**ADDENDUM  
NO. 3**

**September 30, 2025**

**VALE FACILITY ADDITION/RENOVATIONS AND  
MAINTENANCE/IT FACILITY PROJECTS**

**Addendum Three (AD.03)** to the drawings and specifications prepared by Gibraltar Design for **Valparaiso Vale Facility Addition/Renovations and Maintenance/It Facility and Related Work** for Valparaiso Community Schools, Valparaiso, Indiana.

**GENERAL ELEVATION NOTES:**

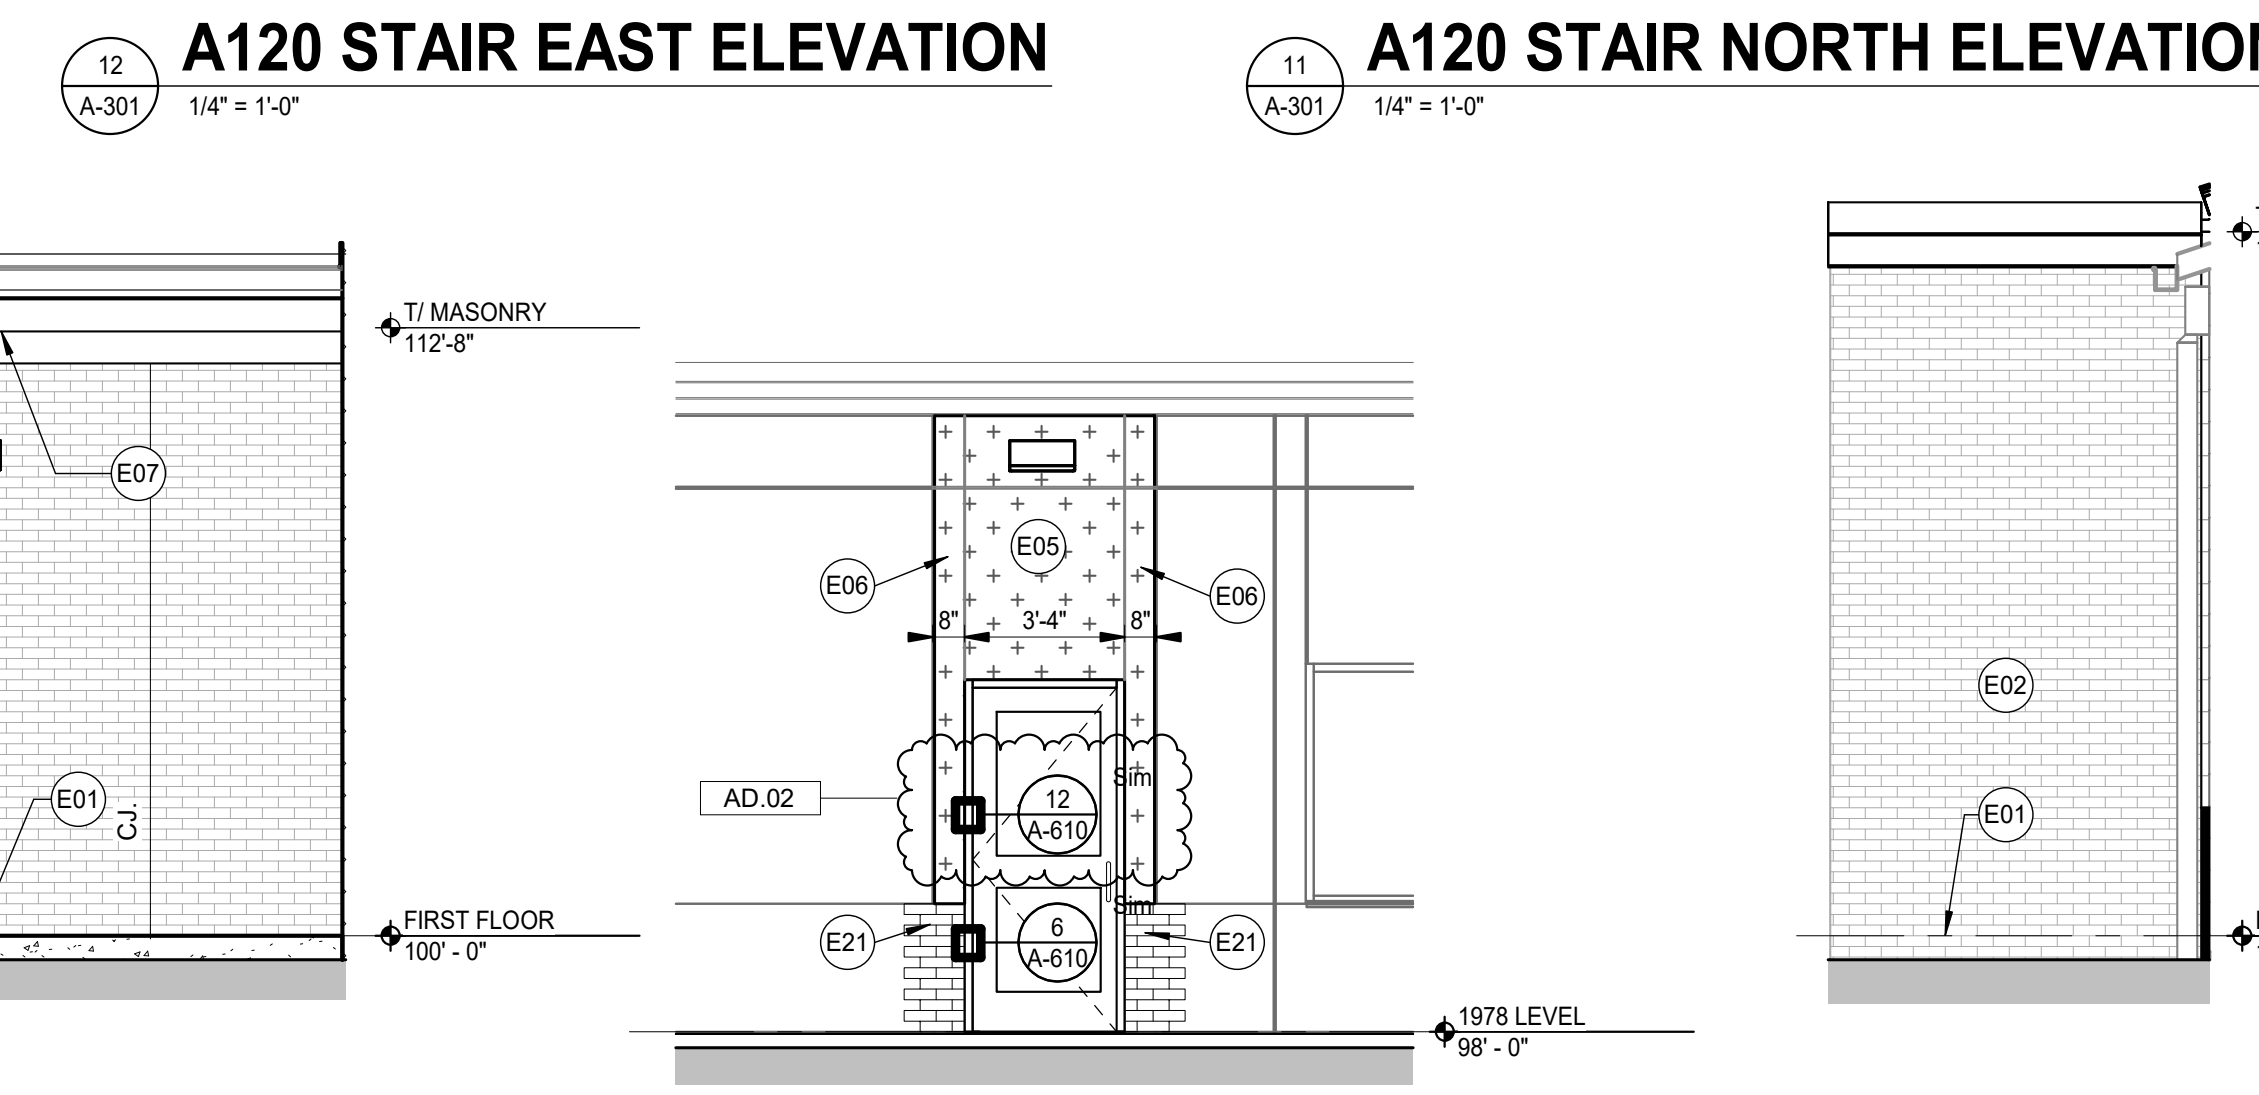
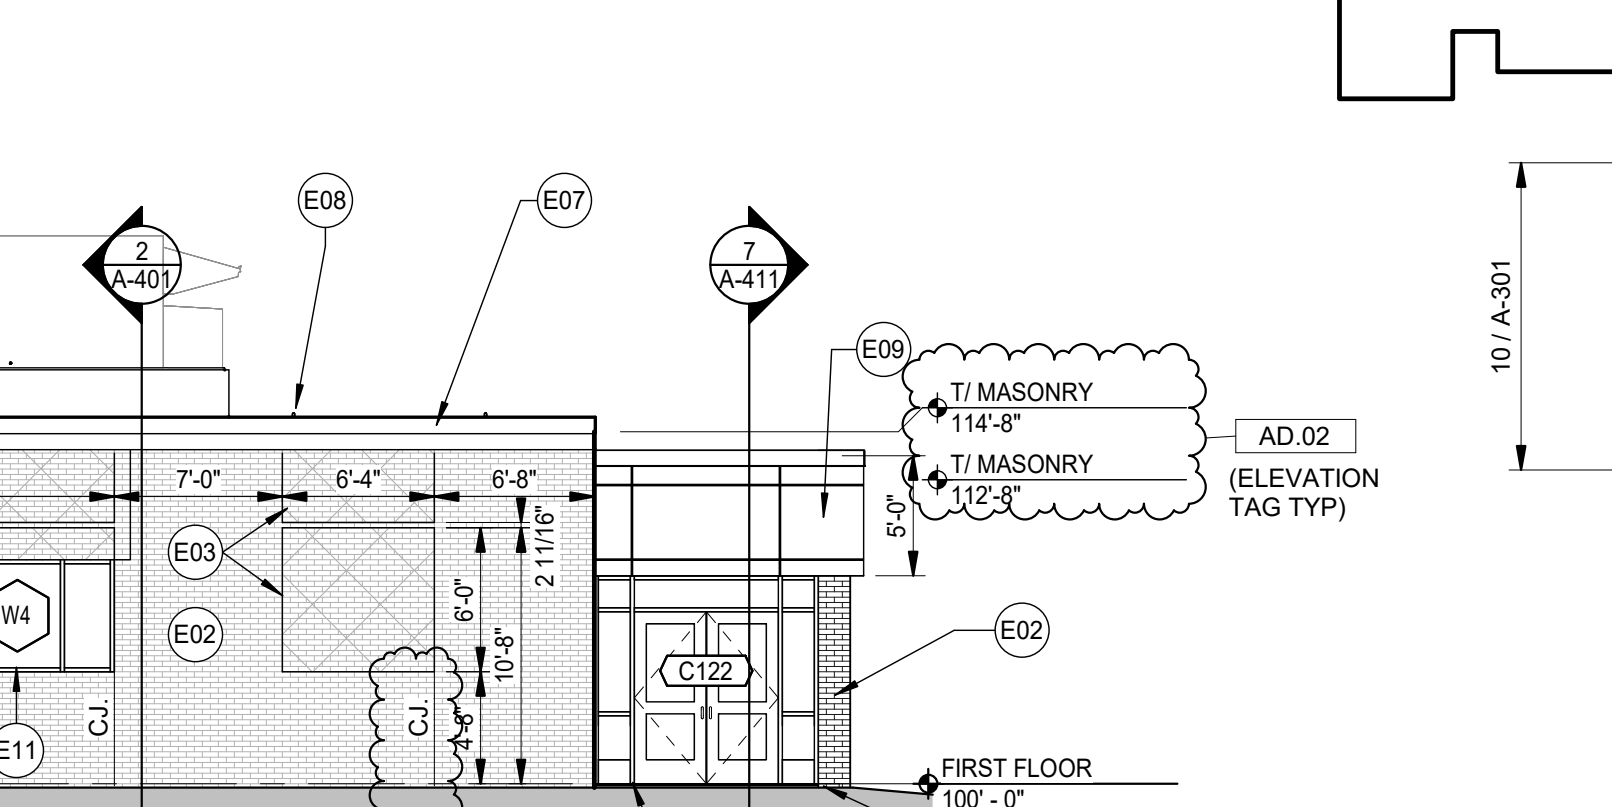
- A. Refer to revised, full-size drawing, included in this Addendum, for revisions.
  1. Added references to detail 1/A-501 at Exterior Elevation 1 and 6.
  2. Modified note E16 to refer to detail 1/A-501.
  3. Added control joints on elevations.
